Responses to NRC Letter Dated August 19, 1997 and December 5, 1997, Regarding NRC
Acceptance Review of the Reclamation Plan for the White Mesa Uranium Mill

**Response to Nuclear Regulatory Commission / White Mesa Mill Reclamation Plan
Comments Dated August 19, 1997
Source Material License SUA-1358**

Response to Nuclear Regulatory Commission / White Mesa Mill Reclamation Plan
Comments Received December 8, 1997
Source Material License SUA-1358

SUBSURFACE CROSS SECTION B-B'

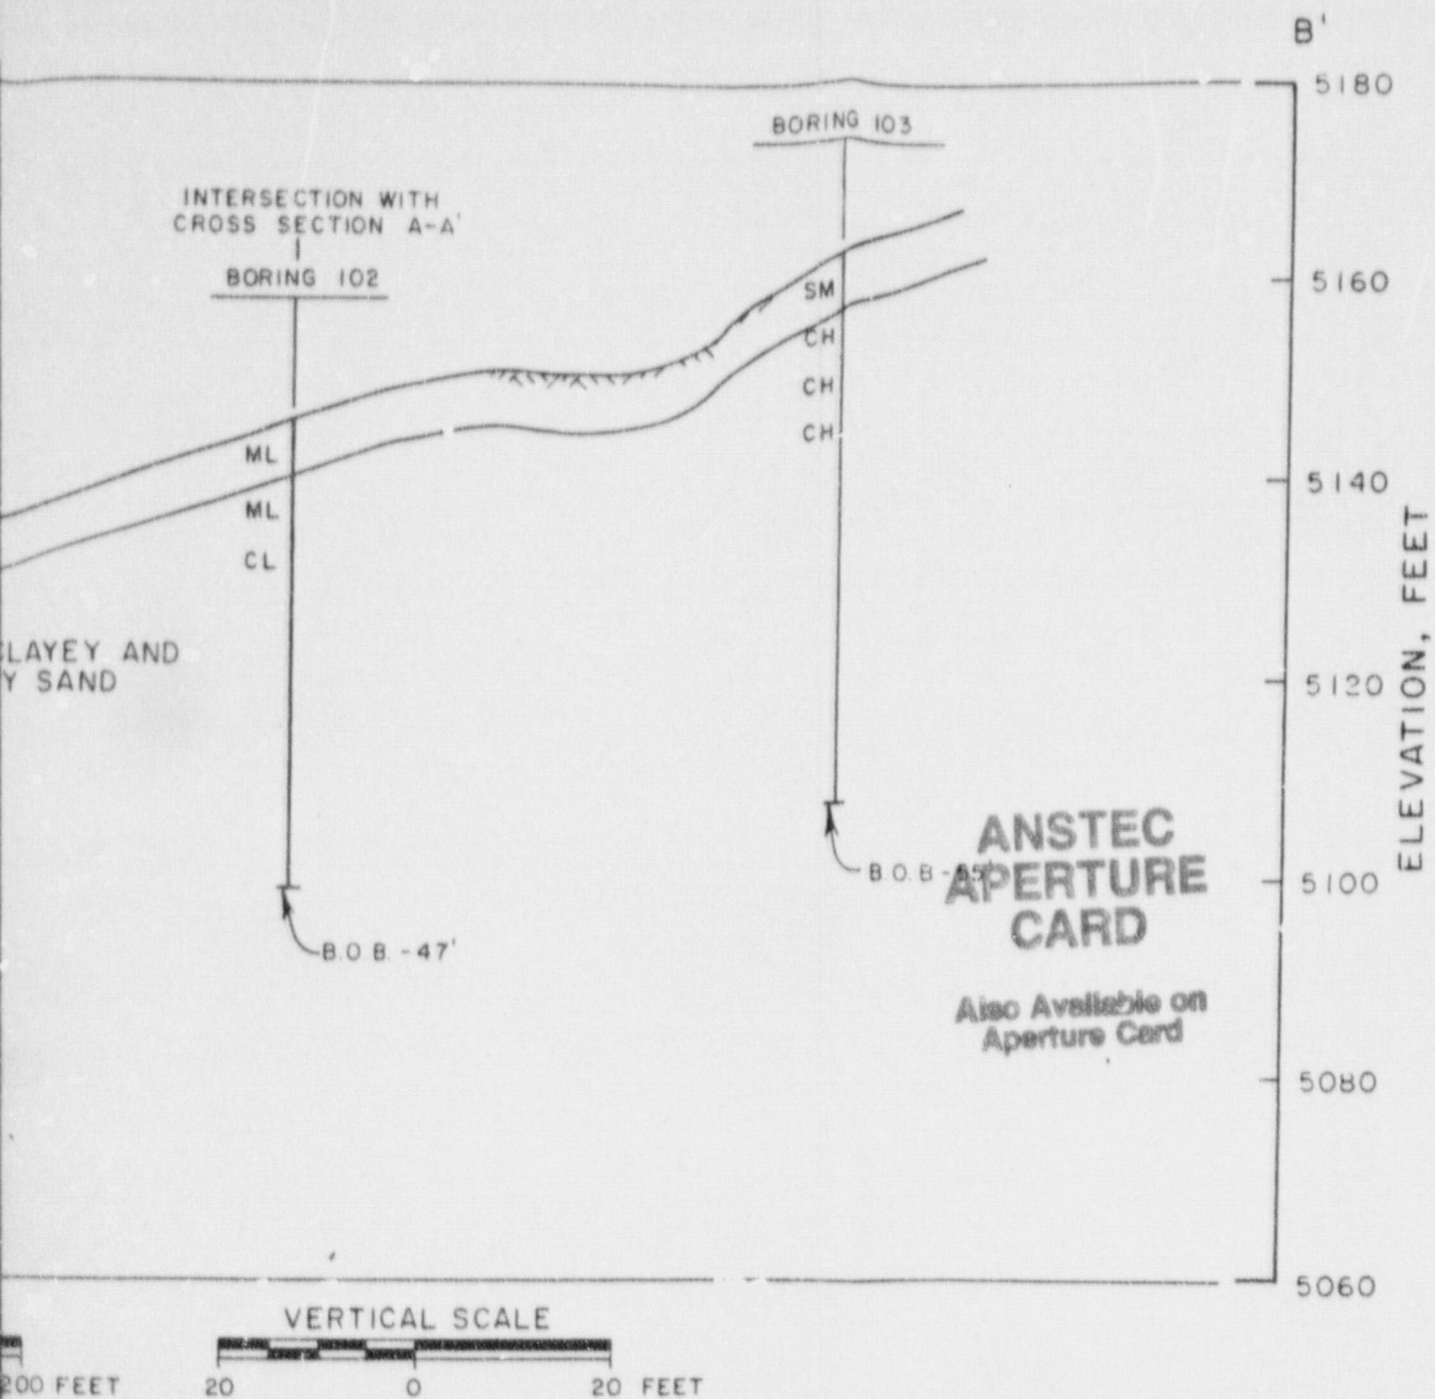
The subsurface conditions in the canyon, based on the boring data, are shown on Cross Sections A-A' and B-B' presented on Figures 2 and 3, respectively. The plan locations of these cross sections is shown on Figure 1. As shown on the cross sections, the subsurface consists of a surficial layer of red clayey and silty sand about five feet thick. The underlying material is mostly a red or gray silty clay. The consistency of the silty clay layer varies from stiff to hard, based on observations of the drillers and rig during drilling. A lense or layer of very hard silt was noted in Boring 105. This layer appears to be a well cemented unit from the cutting samples obtained. In Boring 106, the surficial sand layer was about 20 feet thick and a clayey sand layer was also encountered at a depth of about 30 feet.

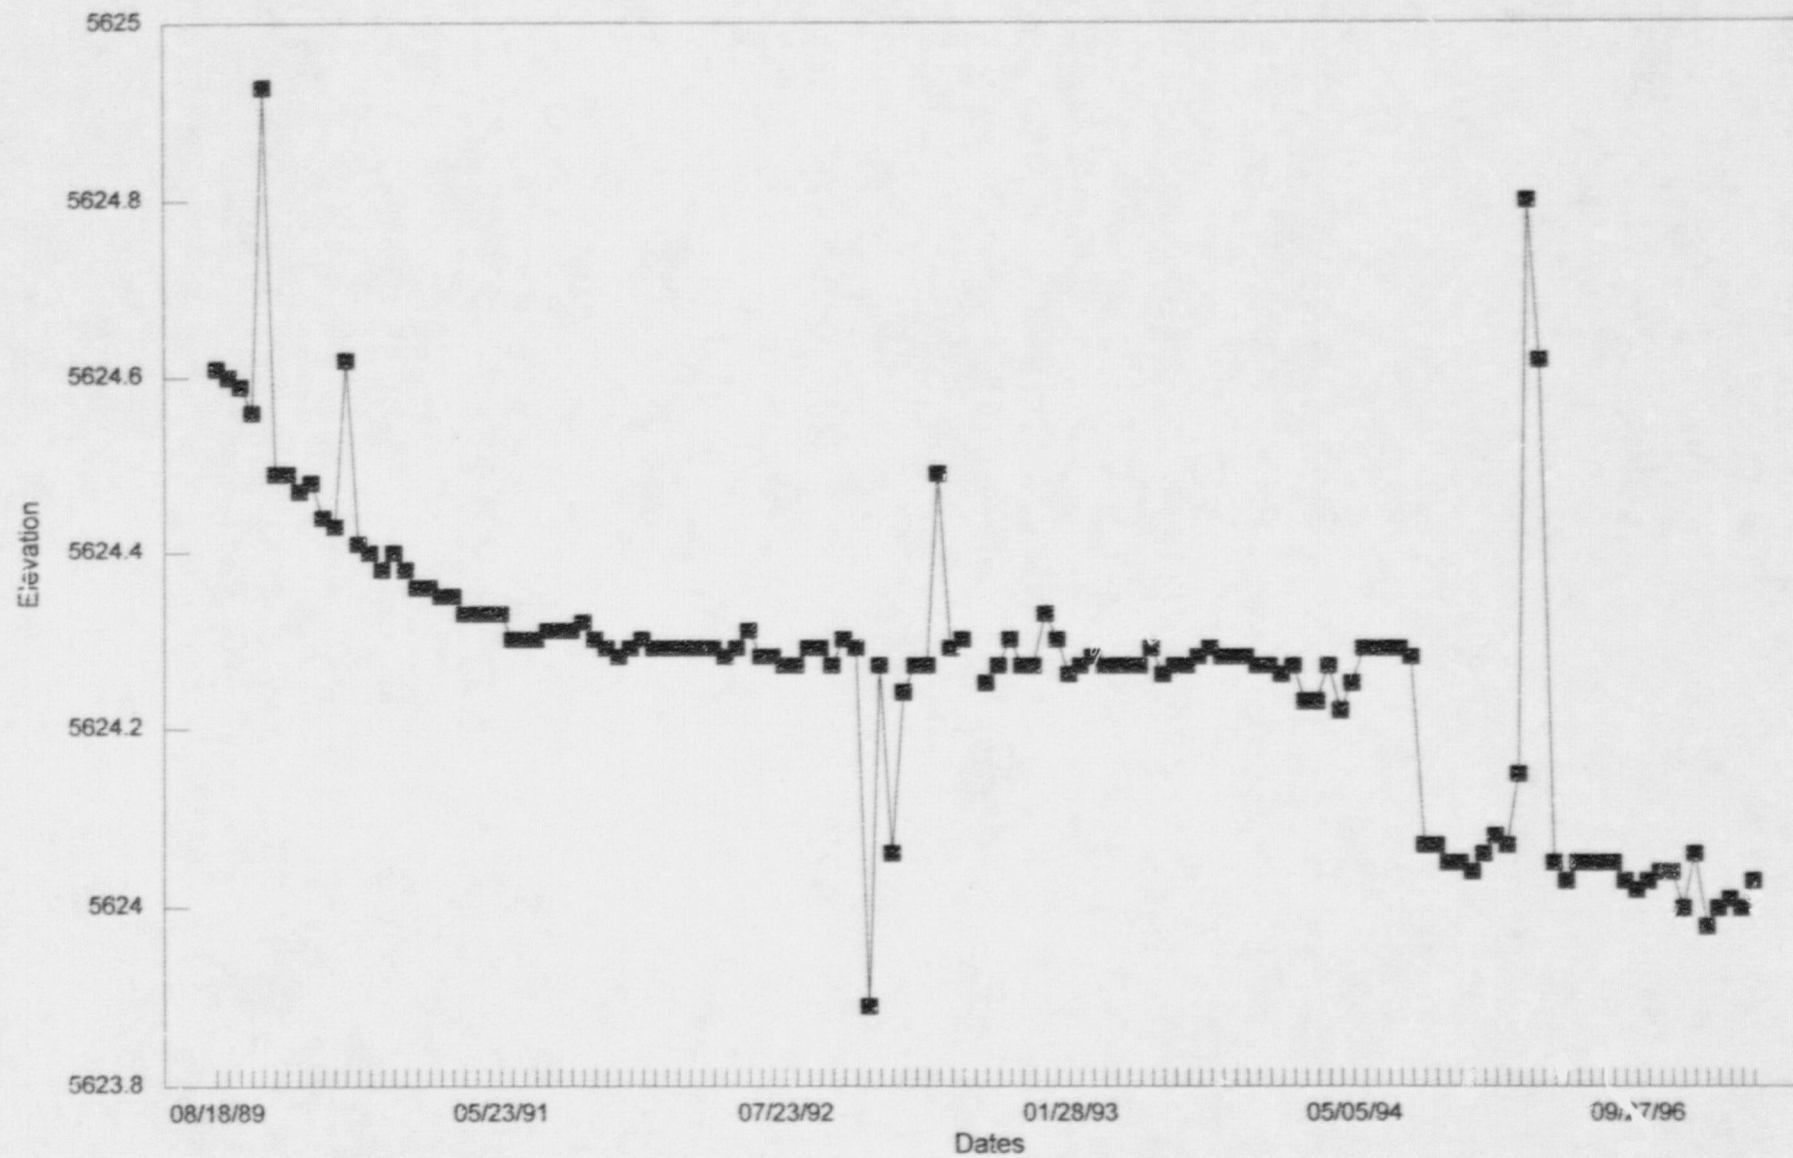
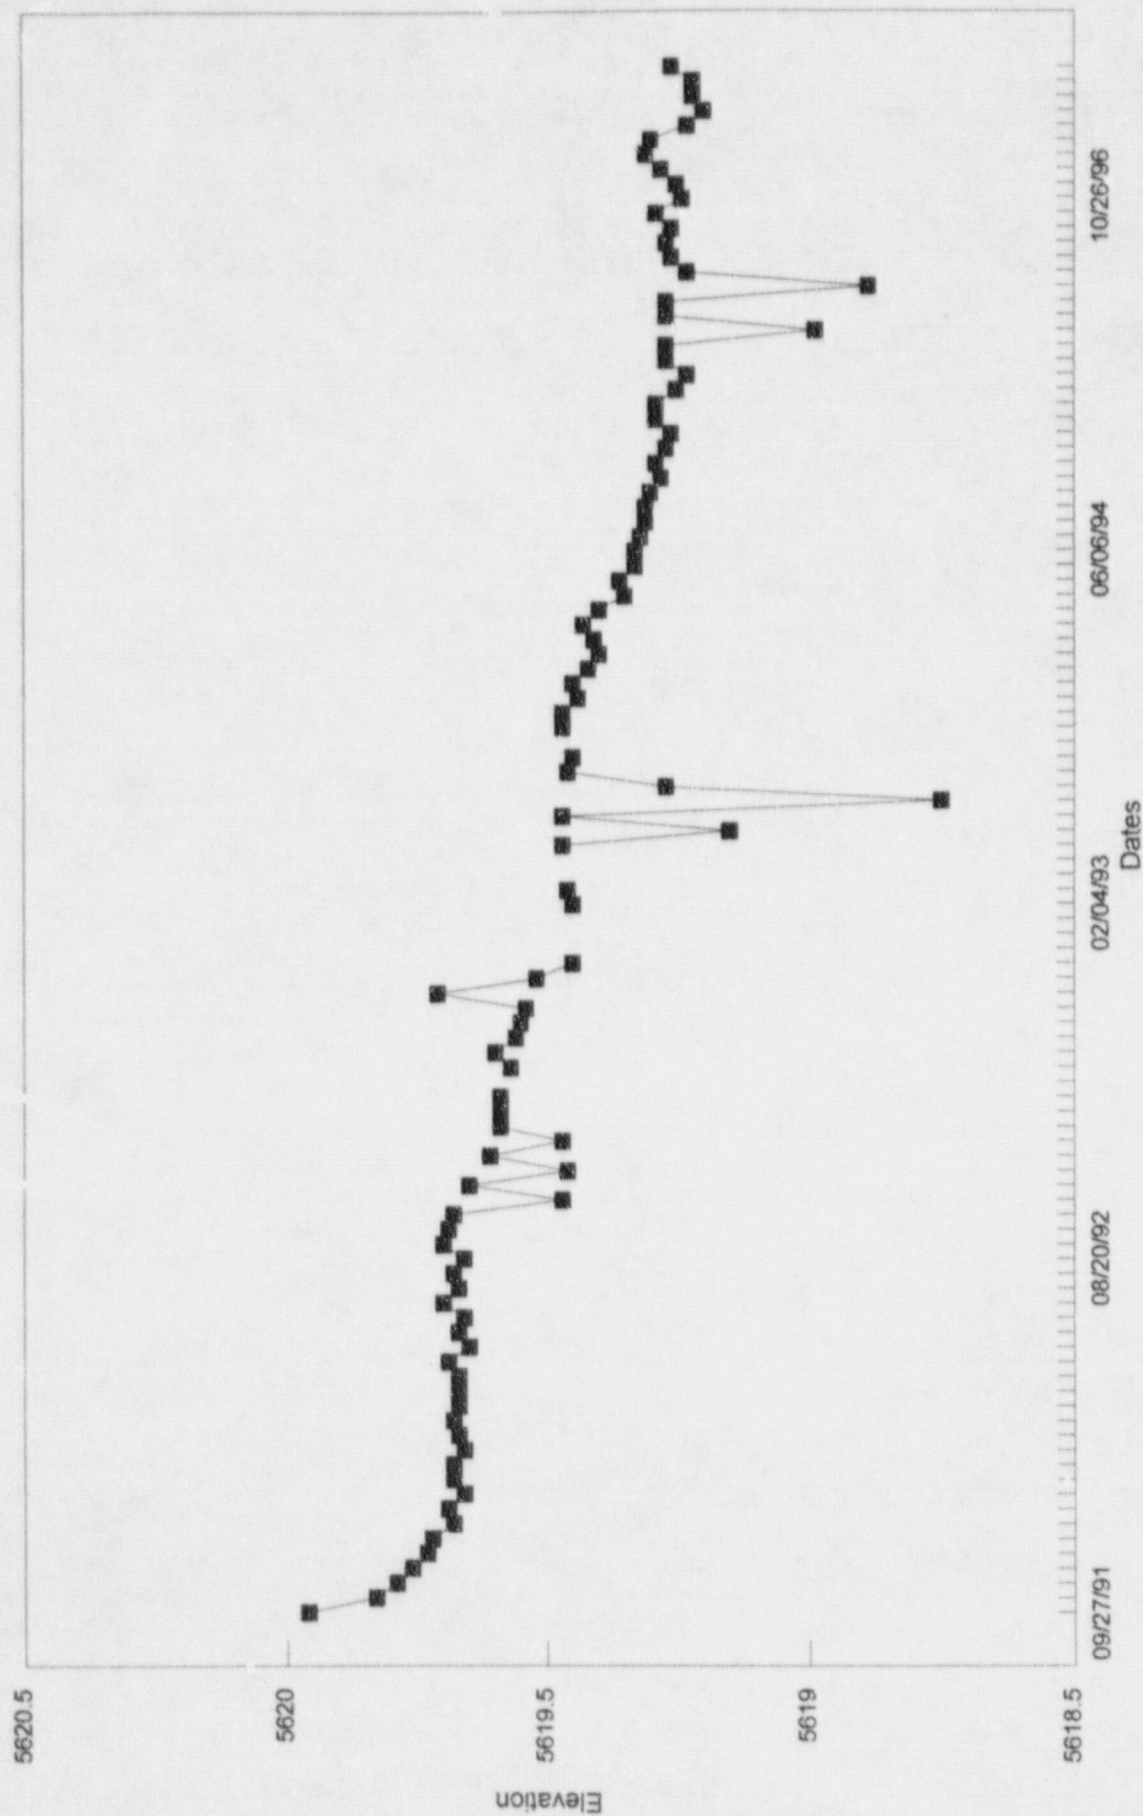
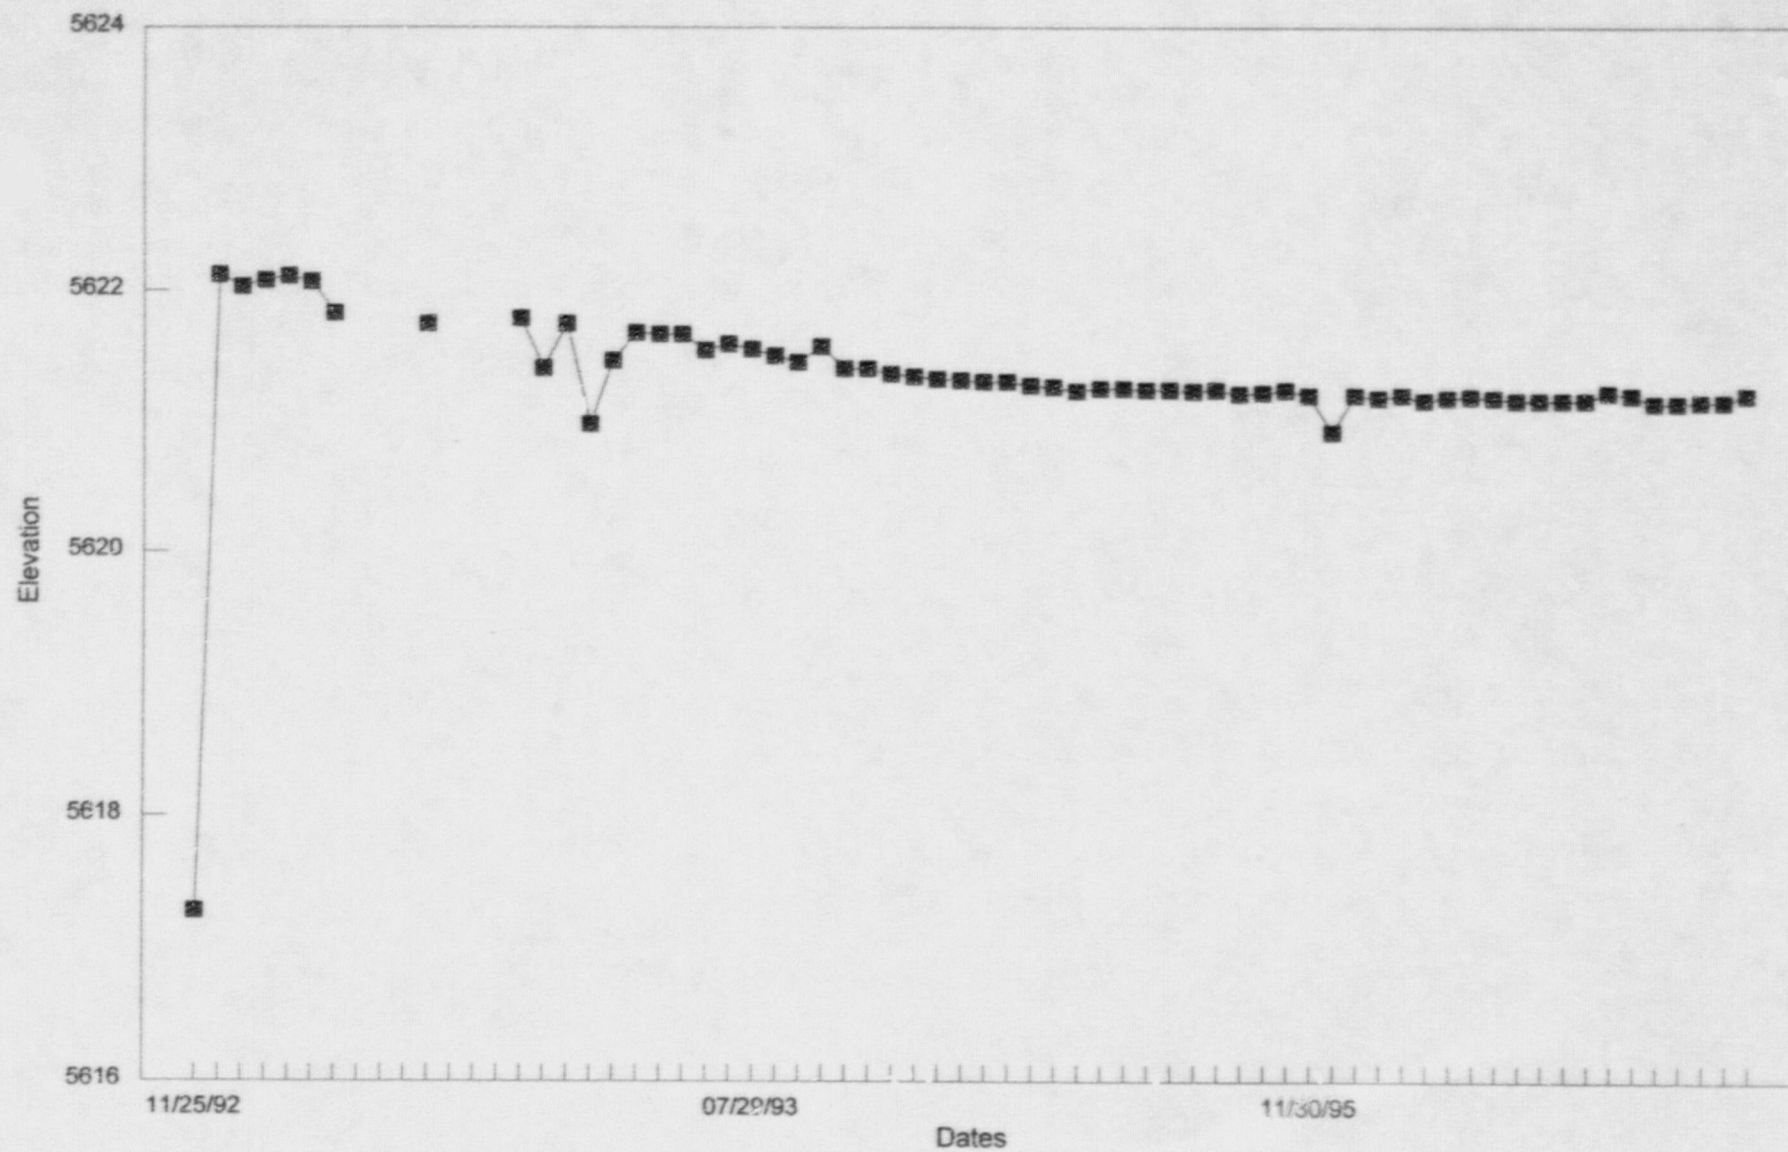
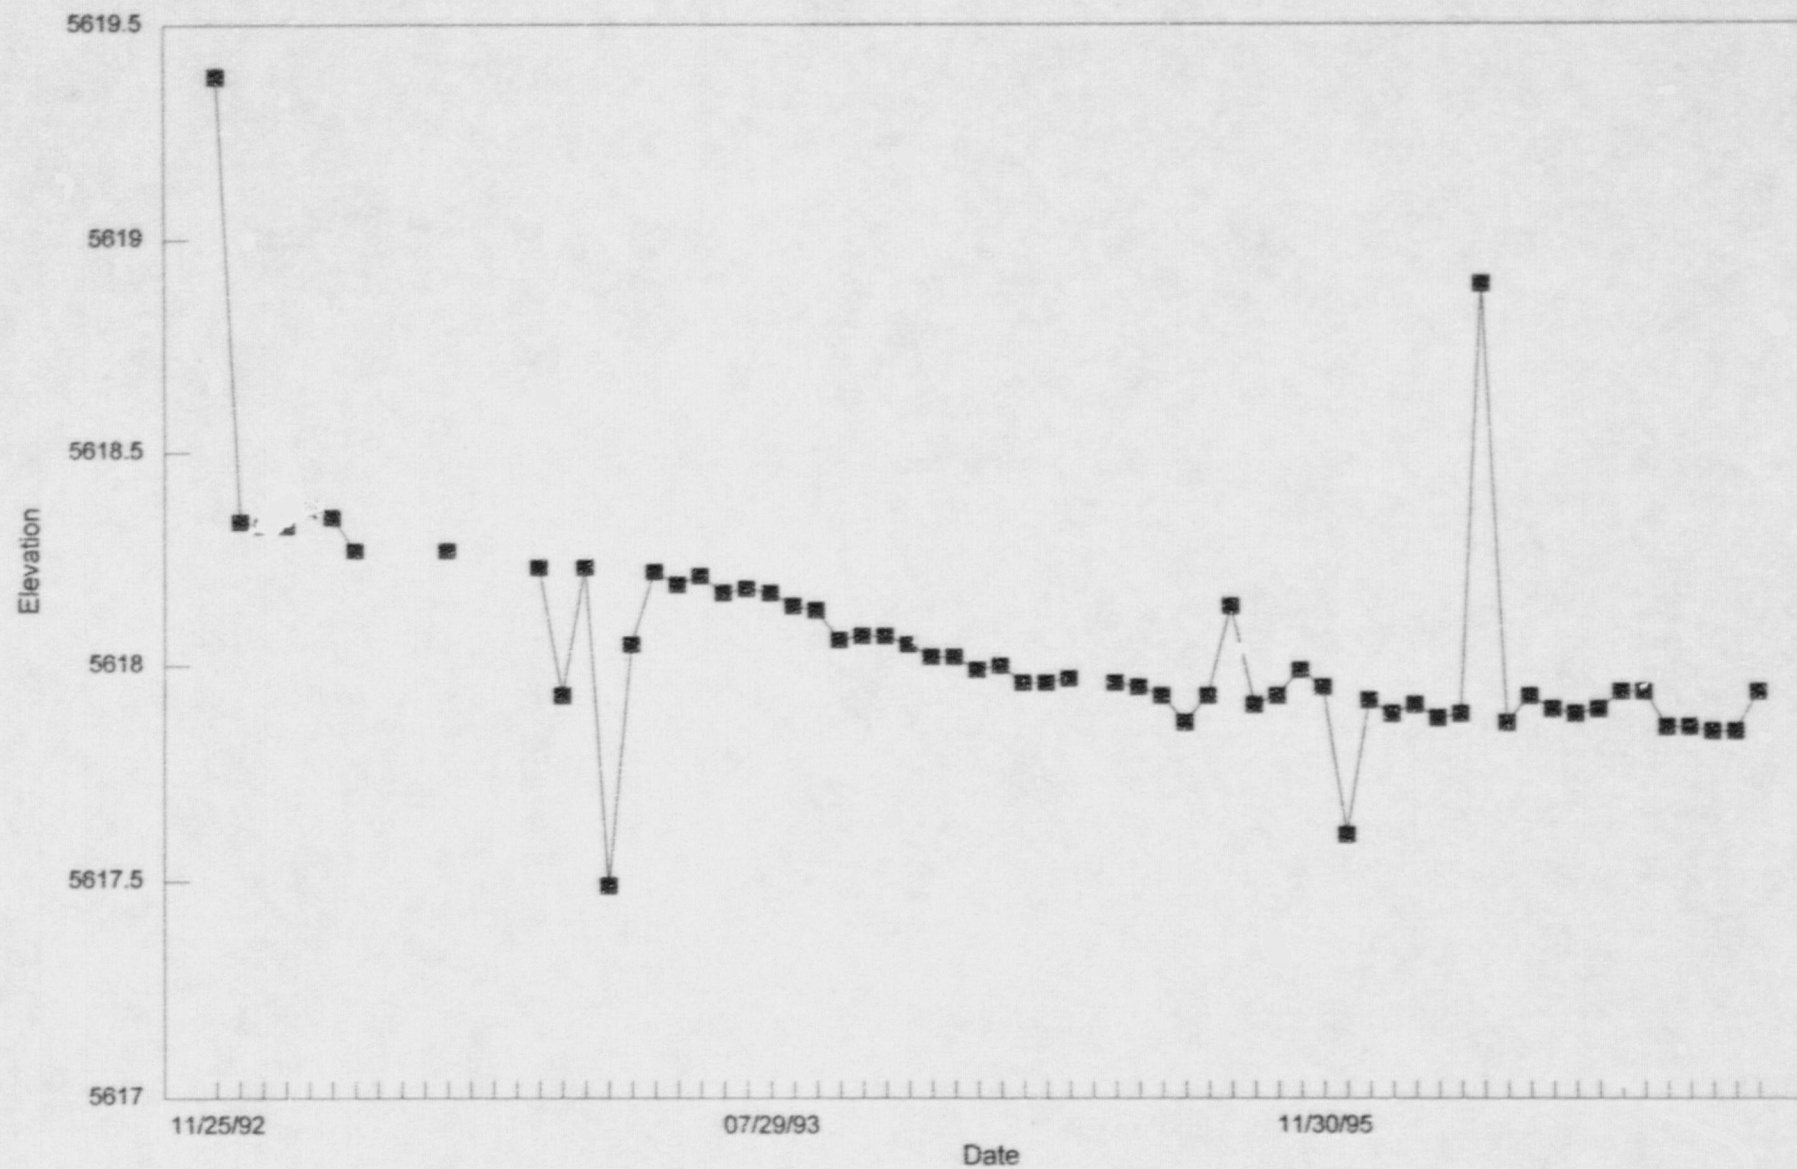
(2) An analysis of the total and differential settlements of the tailings surface and the effects of such settlements on soil cover integrity.

Analysis of the total and differential settlement of the tailings surface was performed using the survey data compiled for the five settlement monuments installed within Cell 2. These monuments were installed on the surface of the tailings, between August 1989 and November 1992, prior to the placement of approximately three to four feet of random fill material. Survey results of each monument were plotted as time vs. settlement graphs and are presented in Attachment 2 of this response.

Review of the survey data and graphs shows that primary consolidation of the tailings has occurred, and the settlement rate has been very slow with minor total values. The maximum total settlement recorded is 0.97 feet, and the differential settlement is on the order of 0.50 feet. Approximately 81 percent of the total measured settlement occurred within the initial three years. Additionally, recent survey data indicates that the settlement has virtually stopped. From September 1995 to September 1997 the settlement averaged less than 0.03 feet per year, which is within the expectable survey error of 0.05 feet. This indicates that the settlement since 1995 is negligible.
